Subject: 22-06-17 RE: Eversource V191 Line Bedford Merrimack AoT 220412-082 Attachments: NHFG Review NHB21-3901 Eversource V191 Line Bedford Merrimack AoT

Based on the NHB datacheck results letter and the information provided in the submission, we request the following recommended permit conditions be incorporated into the sheet plans as written below (updated highlighted text as applicable) and provided to NHDES and cc NHFG for final review.

New Hampshire Fish and Game AoT Permit Conditions in accordance with Env-Wq 1503.33 – Wildlife Protection Notes:

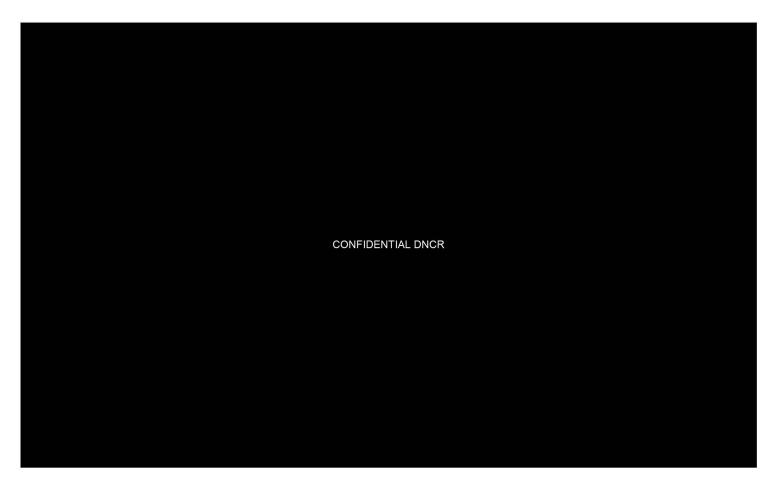
Kim- the orange is the approximate location of the eagle nest taken from the NHB map and the red line is the V191 corridor. It looks to me like the nest would be >250' from the work, assuming the nest is along the edge of the river. Please "reply all" with any comments or suggested conservation measures—Im retiring tomorrow and Katy Wilkins will be taking over for this project. Thanks!
